## **EXHIBIT A-6**

### **ADDENDA**

**NORTHERN KENTUCKY WATER DISTRICT  
TAYLOR MILL TREATMENT PLANT  
TMTP UPGRADES & IMPROVEMENTS  
Project No. WX21117018**

**ADDENDUM NO. 1**

**ATTACHMENT 2-D**  
**REVISED SHEET P3.1**

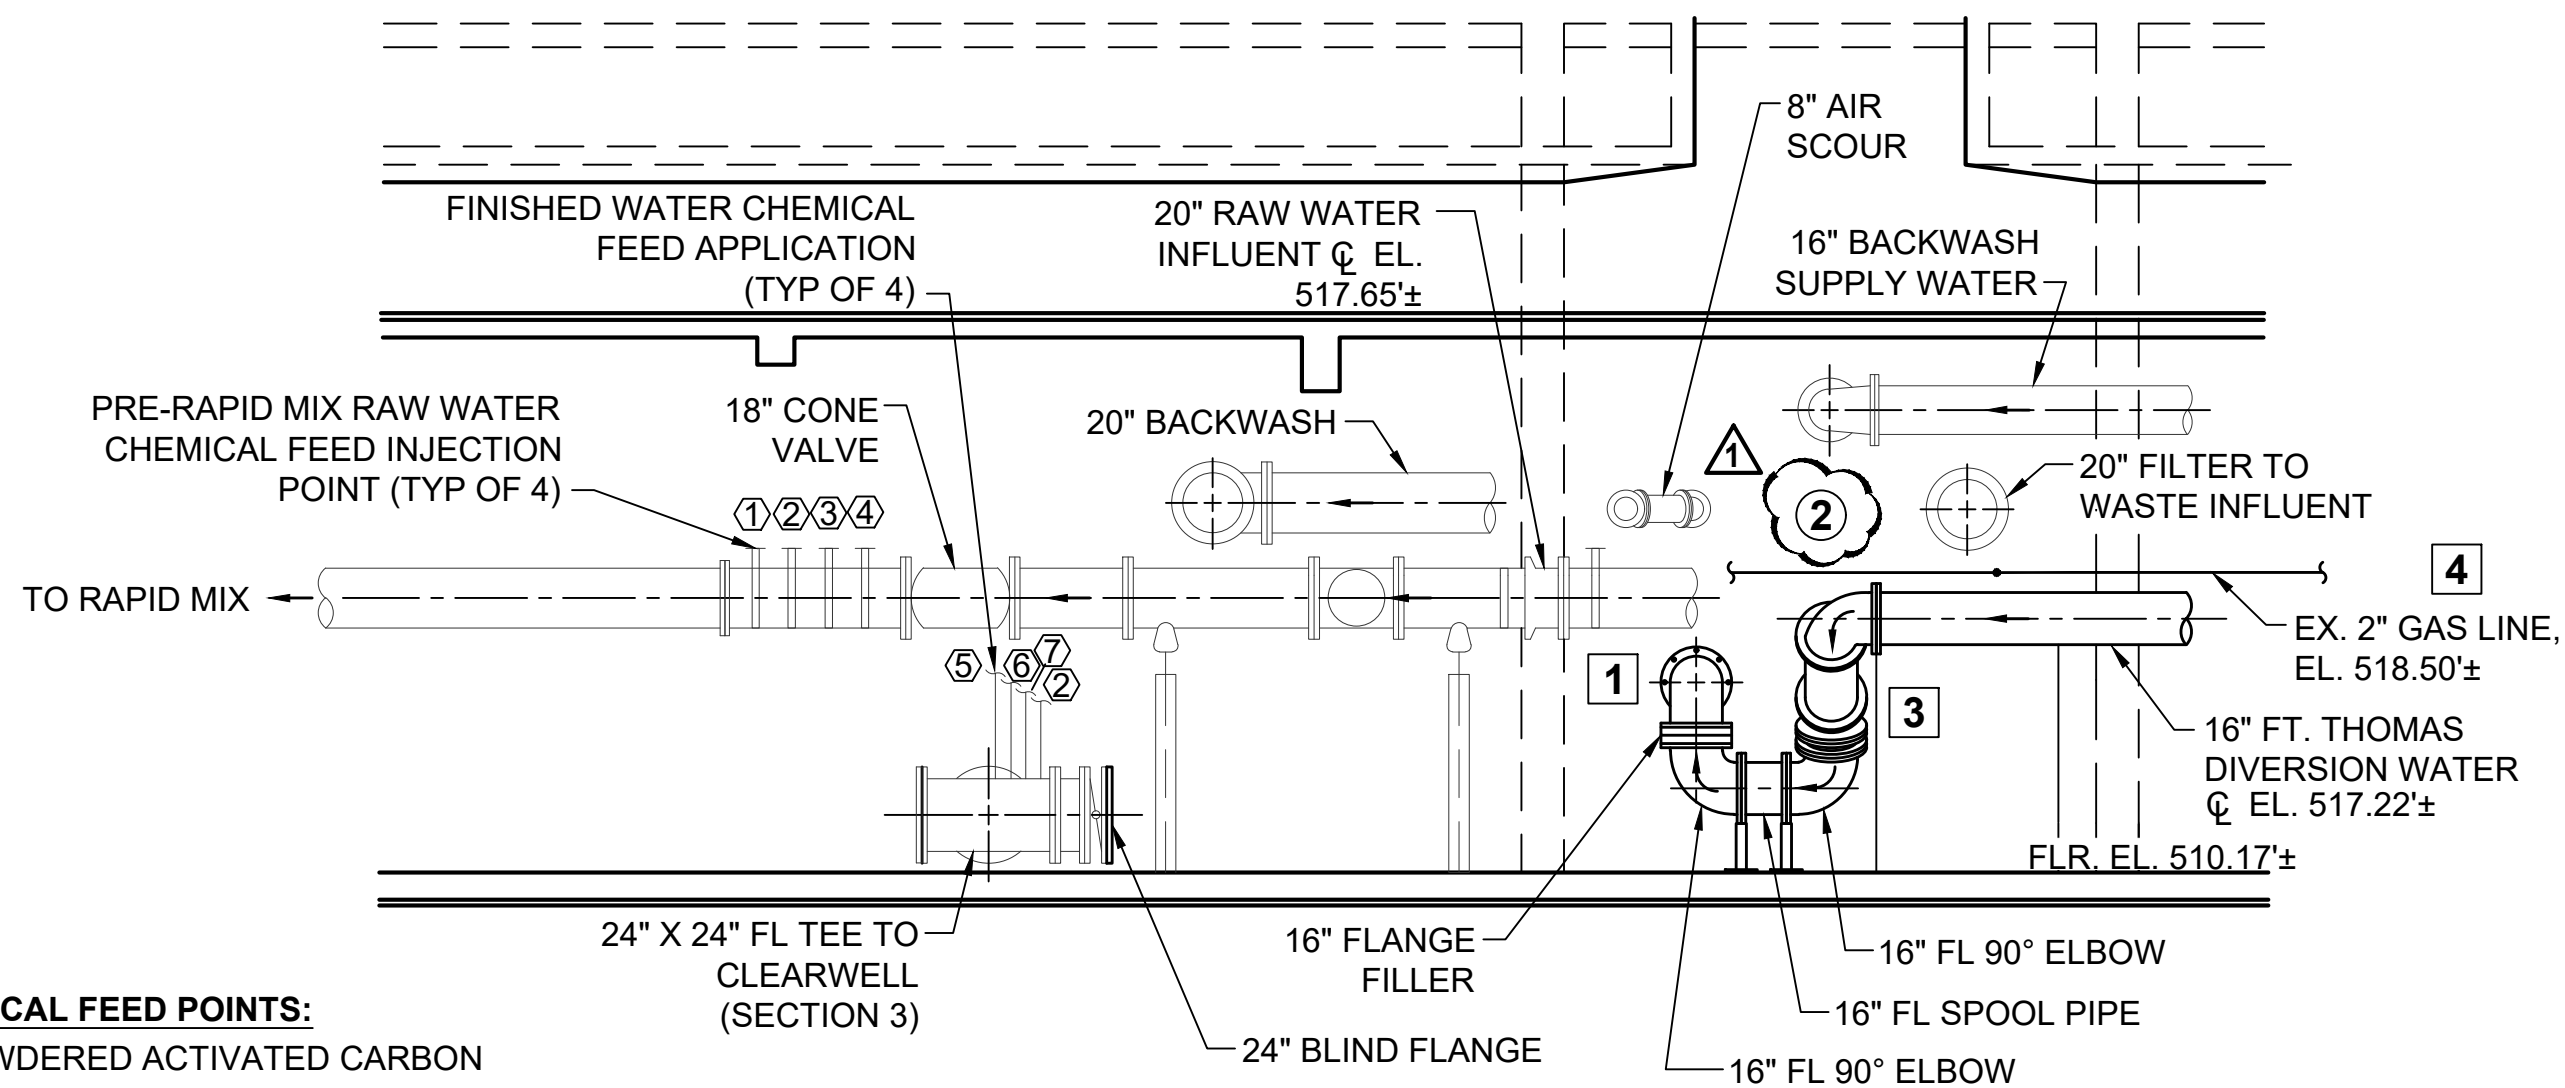
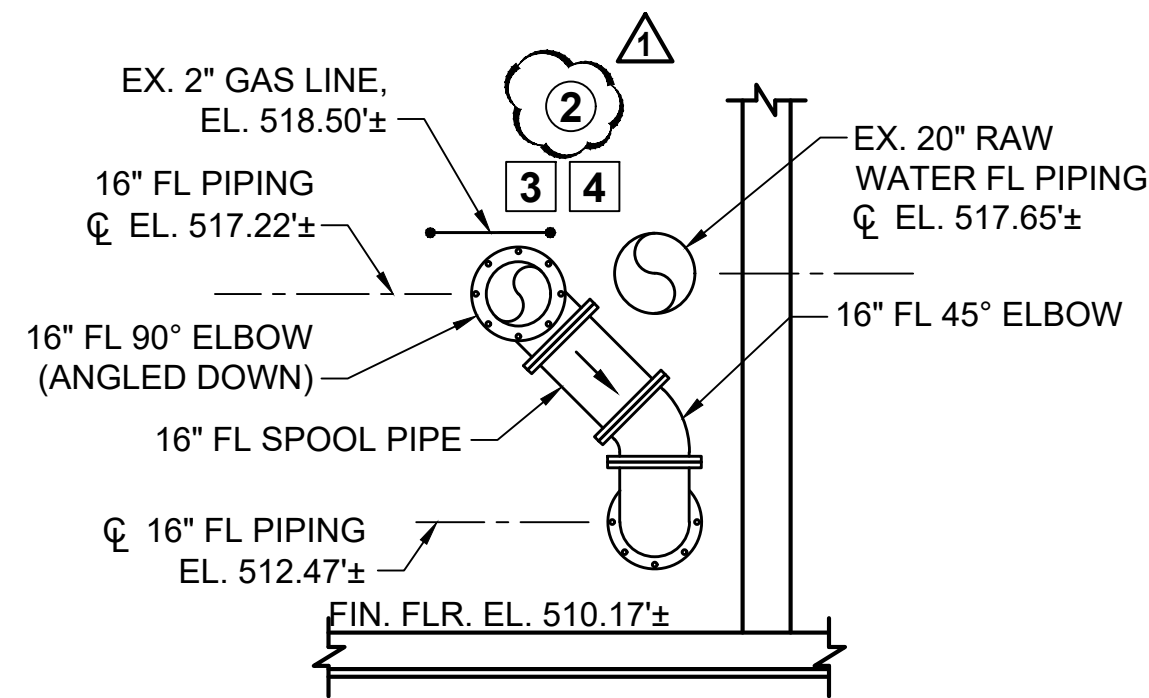
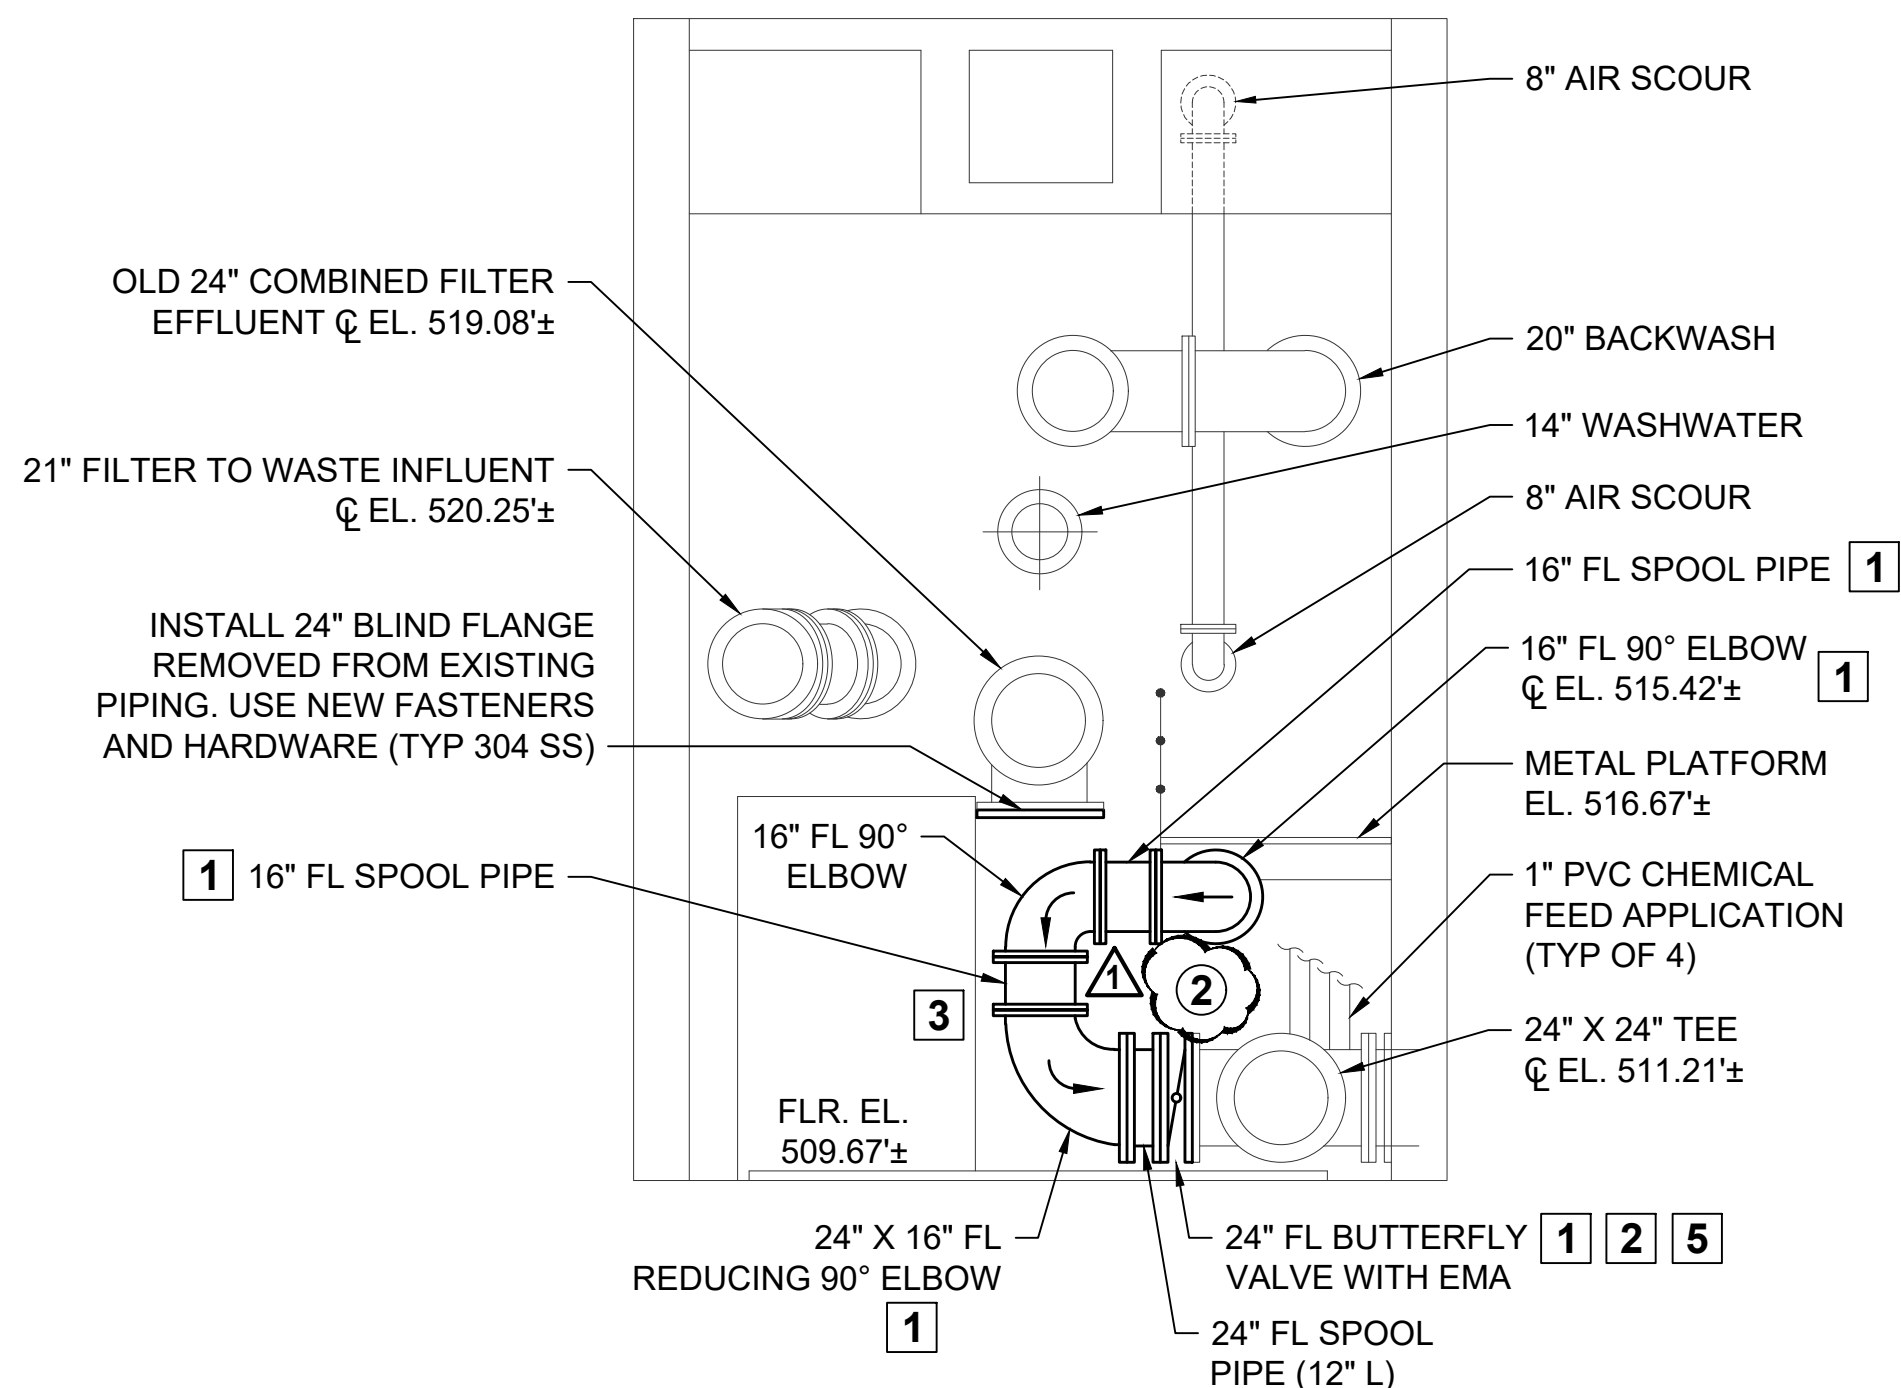
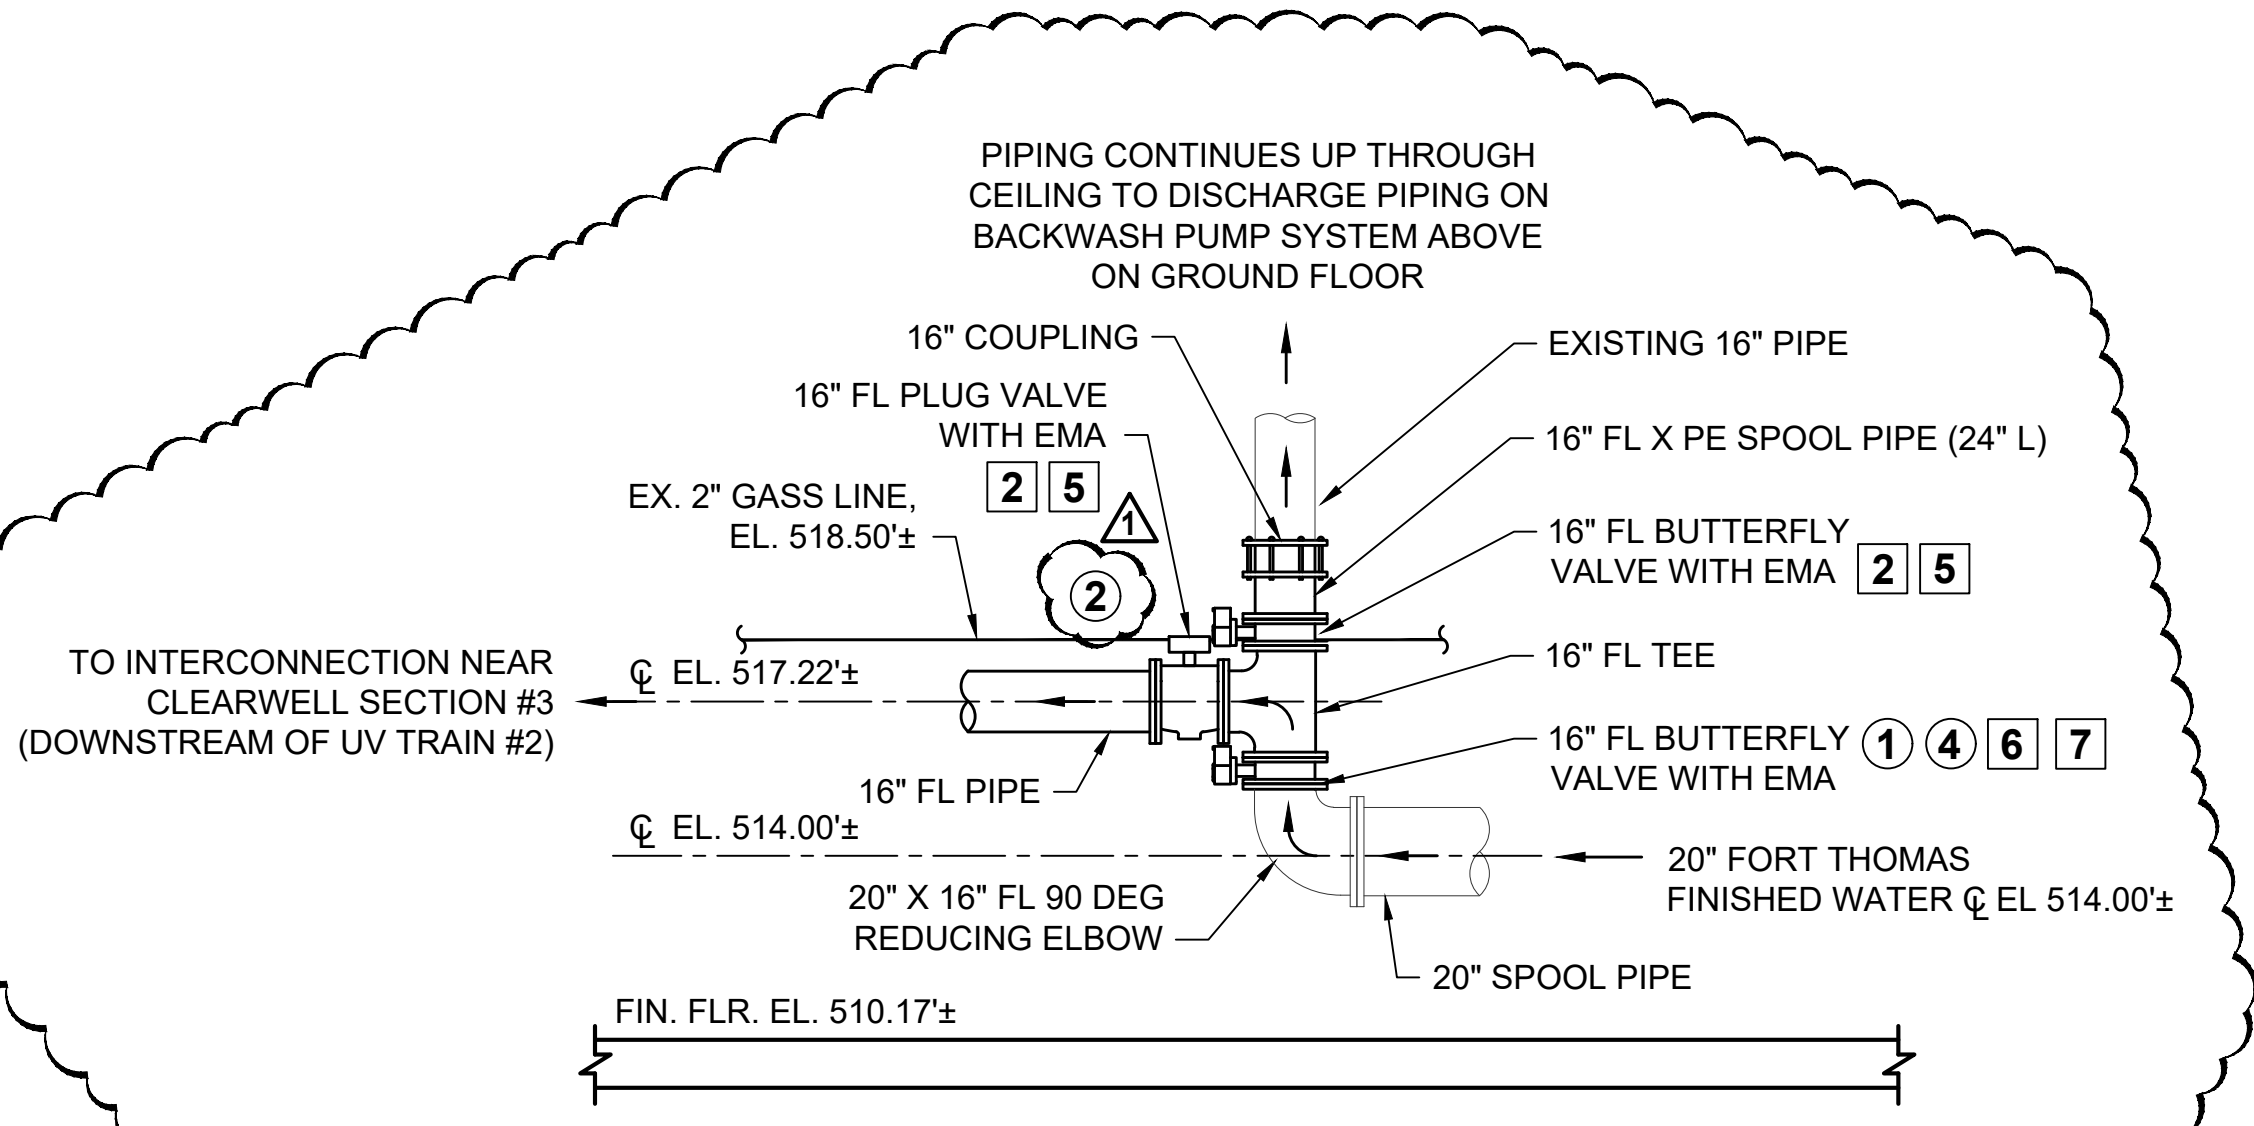
- Delete in its entirety
- Insert new Sheet P3.0, Add Alternative Bid Item: Ft. Thomas Diversion Piping Plan & Sections, provided in Attachment 2-C.
- Item 10. Sheet P3.1, Add Alternative Bid Item: Ft. Thomas Diversion Piping Sections

- Delete in its entirety
- Insert new Sheet P3.1, Add Alternative Bid Item: Ft. Thomas Diversion Piping Sections, provided in Attachment 2-D.
- Item 11. Sheet P4.3, Add Alternative Bid Item: Ft. Thomas Diversion Piping P&ID
